SUBJECT: ADMINISTRATION AND EARLY LEARNING CENTER ADDITIONS
ORCHARD FARM R-V SCHOOL DISTRICT
ST. CHARLES, MISSOURI
PROJECT # 23-09C

ORCHARD FARM R-V SCHOOL DISTRICT
ADMINISTRATION AND OFFICE ADDITIONS
ST. CHARLES, MISSOURI

AUGUST 1, 2024

The drawings and specifications are hereby supplemented and amended to include the following particulars:

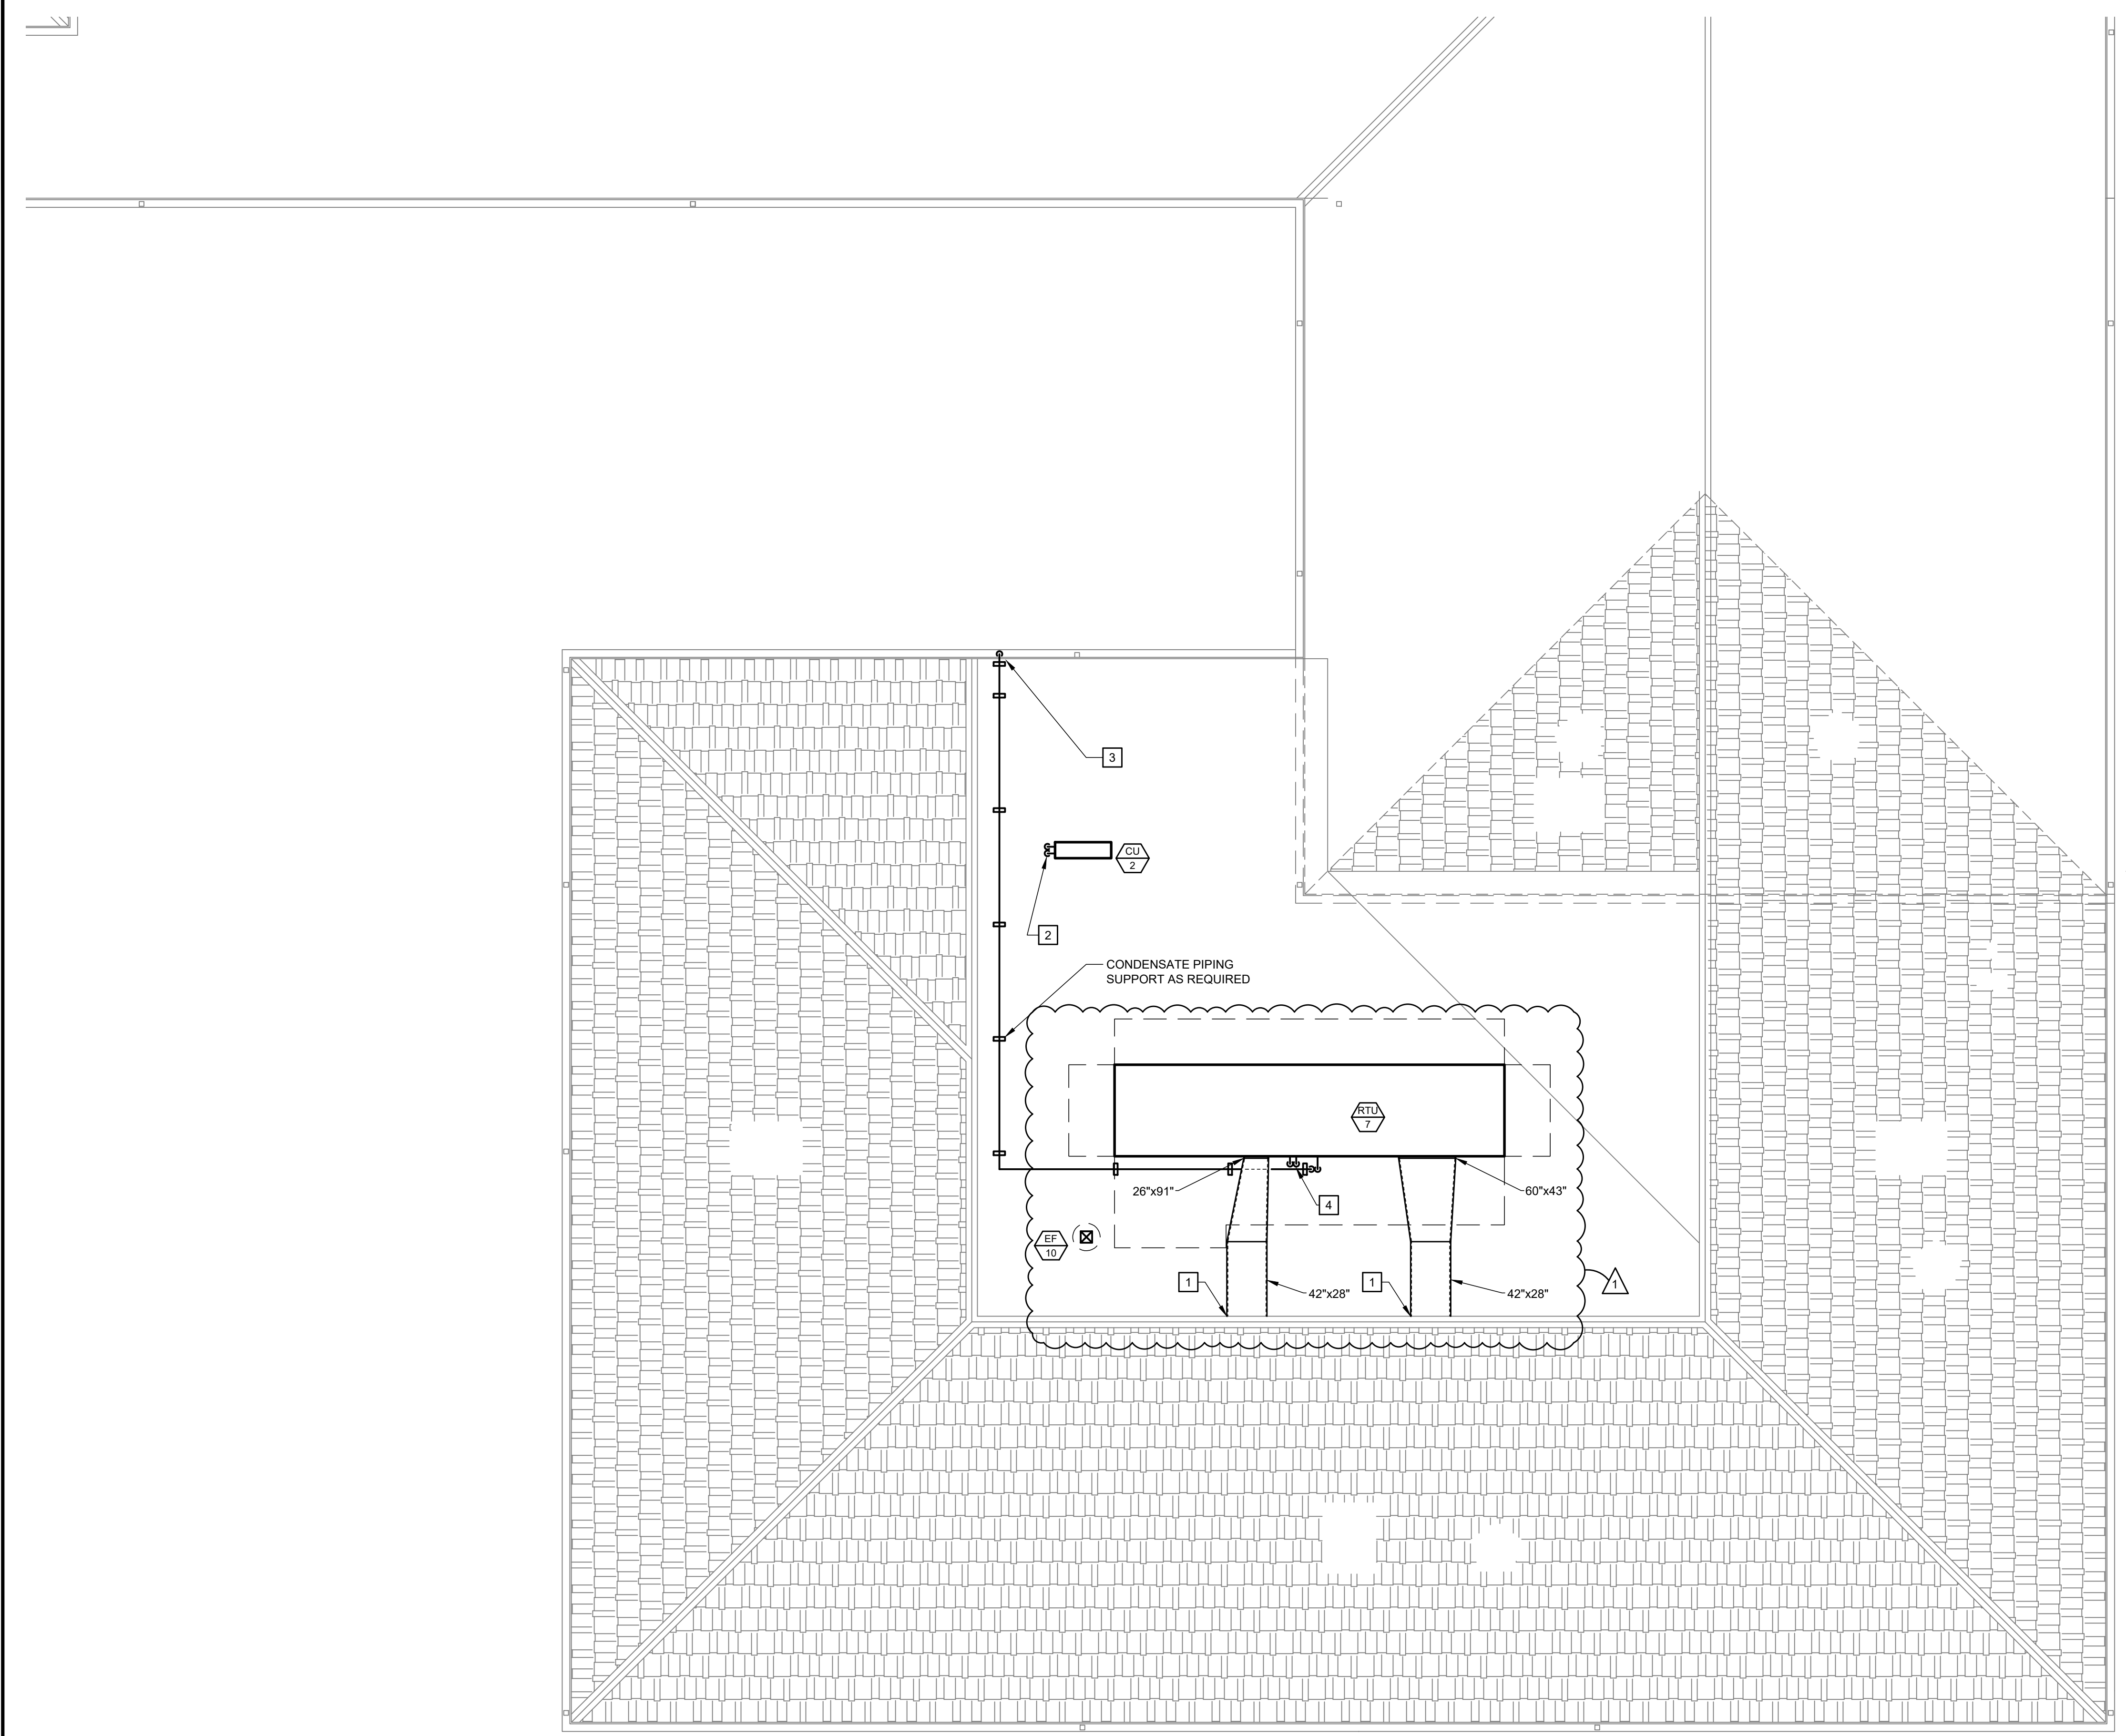
- A. “REVISE” Shift position of RTU-7 as indicated.

M3.3
 SD-13

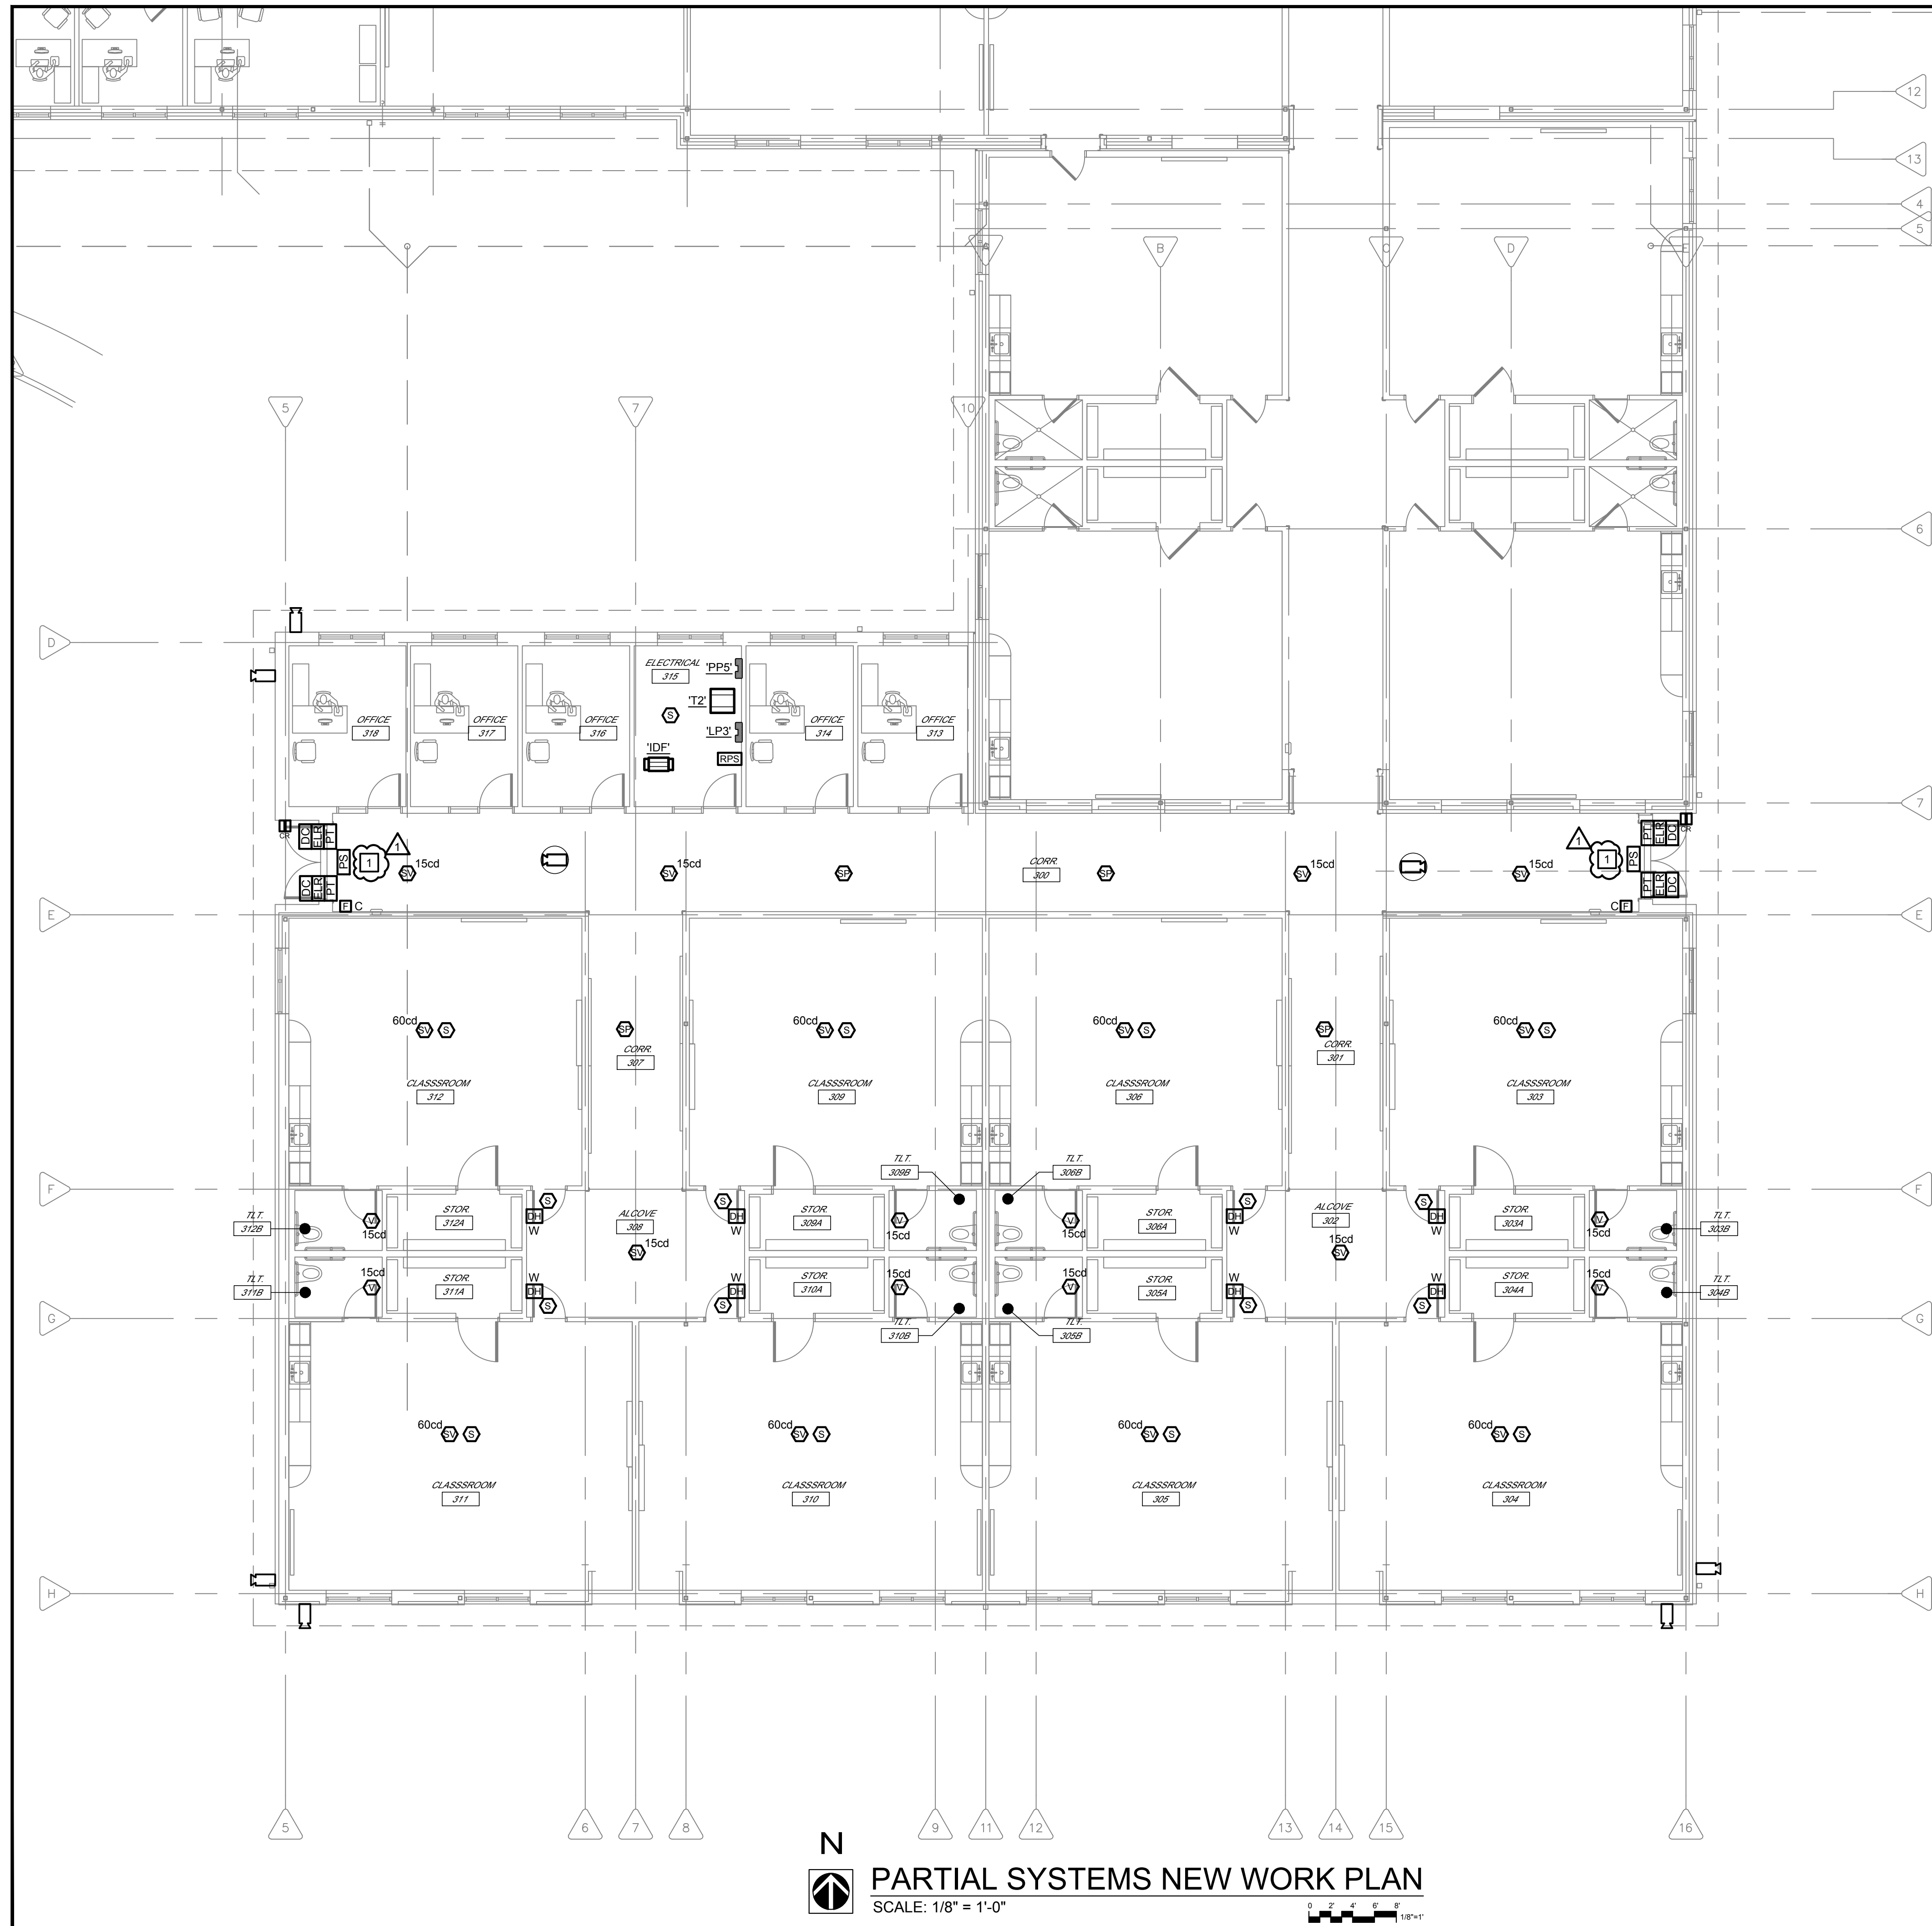
- A. “REVISE” Shift position of RTU-7 as indicated.
